UNITED STATES PATENT AND TRADEMARK OFFICE

10/706,626

Office Action Summary	Application No. 10/706,626	Applicant(s) TAKAHASHI, SHINICHI	
	Examiner Matthew G. Kayrish	Art Unit 2627

DETAILED ACTION

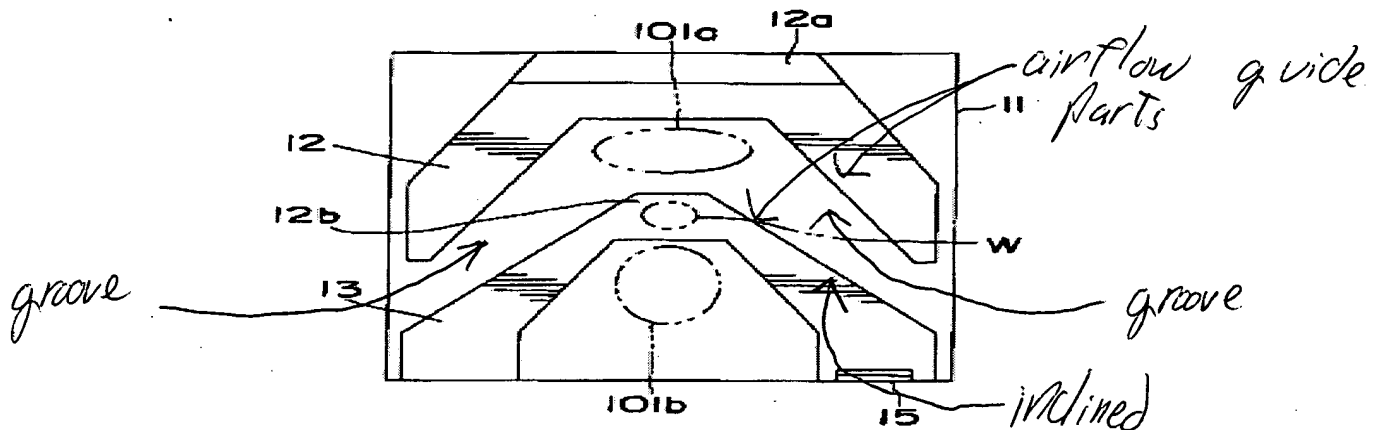
Regarding claim 1, Utsunomiya discloses:

A head slider for a magnetic disk lifted above the magnetic disk by airflow generated by rotation of the magnetic disk, said head slider comprising:

A disk-facing surface having an air bearing surface (figure 7, surfaces of items 12 & 13) and a recessed portion (figure 7, area between items 12 & 13) located behind said air bearing surface when viewed in a direction of the airflow;

An airflow guide part (see figure 7 on page 3) located in said recessed portion and guiding the airflow along the disk-facing surface of said head slider toward sides of the disk-facing surface.

Wherein the airflow guide part includes a first guide groove formed between both sides of the disk-facing surface (figure 7 below).

Regarding claims 2 and 5, Utsunomiya discloses:

The head slider as claimed in claim 1, wherein the airflow guide part is formed to extend in directions each inclined at an angle with respect to a flow direction of the airflow (figure 7 above).

Regarding claim 3, Utsunomiya discloses:

The head slider as claimed in claim 1, wherein the airflow guide part (figure 7, item 101a) includes a capturing part that captures dust included in the airflow (columns 5 & 8, lines 52-58 & 38-42, implies that dust gets trapped in negative pressure regions).

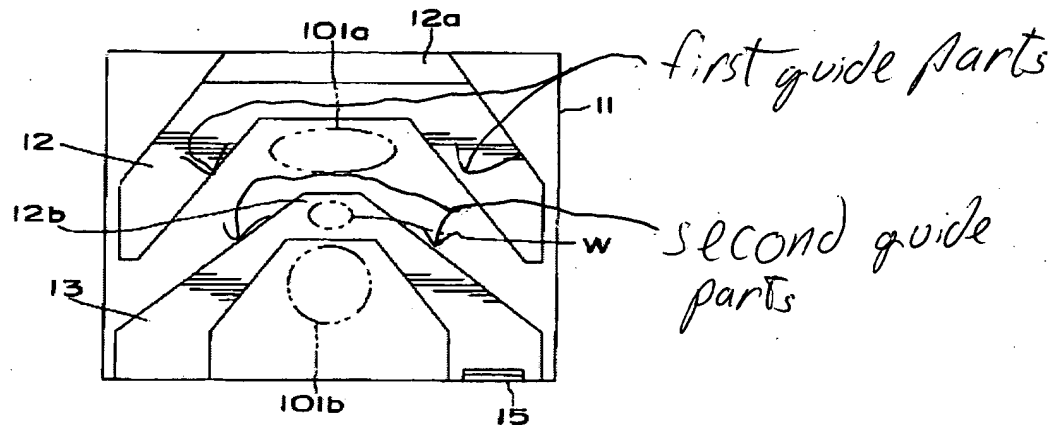
Regarding claim 4, Utsunomiya discloses:

The head slider as claimed in claim 1, wherein the airflow guide part comprises:

A first guide part formed to extend from the vicinity of the center of the disk-facing surface to both sides of the disk-facing surface (figure 7 below); and

A pair of second guide parts formed on opposing side surfaces of said head slider and continuing with said first guide part (figure 7 below).

Regarding claim 6, Utsunomiya discloses:

The head slider as claimed in claim 4, wherein one of the first and second guide parts includes a capturing part that captures dust included in the airflow (figure 7, item 101a is within the first and second guide parts).

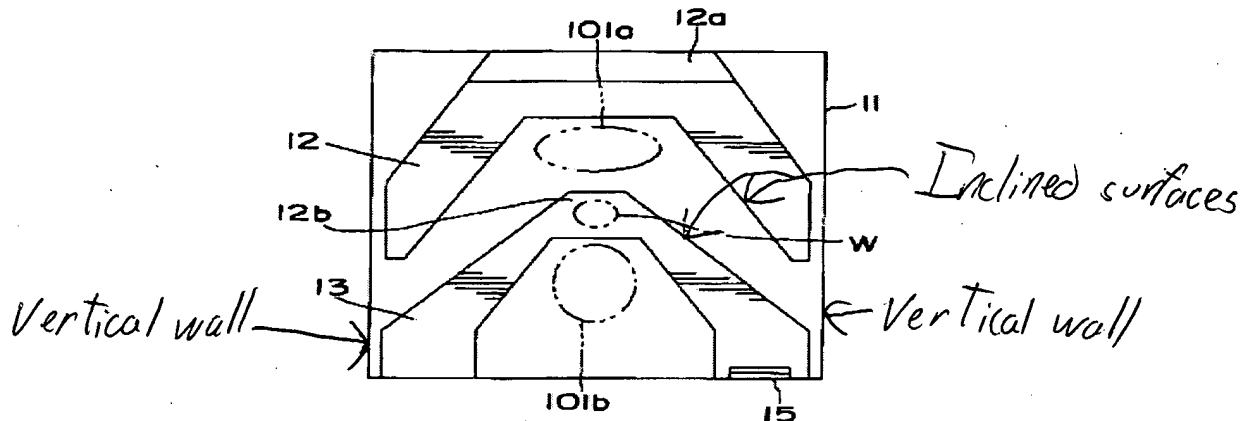
Nakano discloses:

A pair of second guide grooves formed on opposing side surfaces of said head slider (figure 15, item 10c & 10d) and communicating with said first guide groove (figure 15, items 10c & 10d are in connection with the rear out flow area [6]).

Therefore, it would have been obvious to one of ordinary skill in the art at the time the invention was made to provide Utsunomiya with second grooves that are in communication with the first grooves, as taught by Nakano, because this will add another negative pressure region, which will help the head slide to stay in contact with the disk surface.
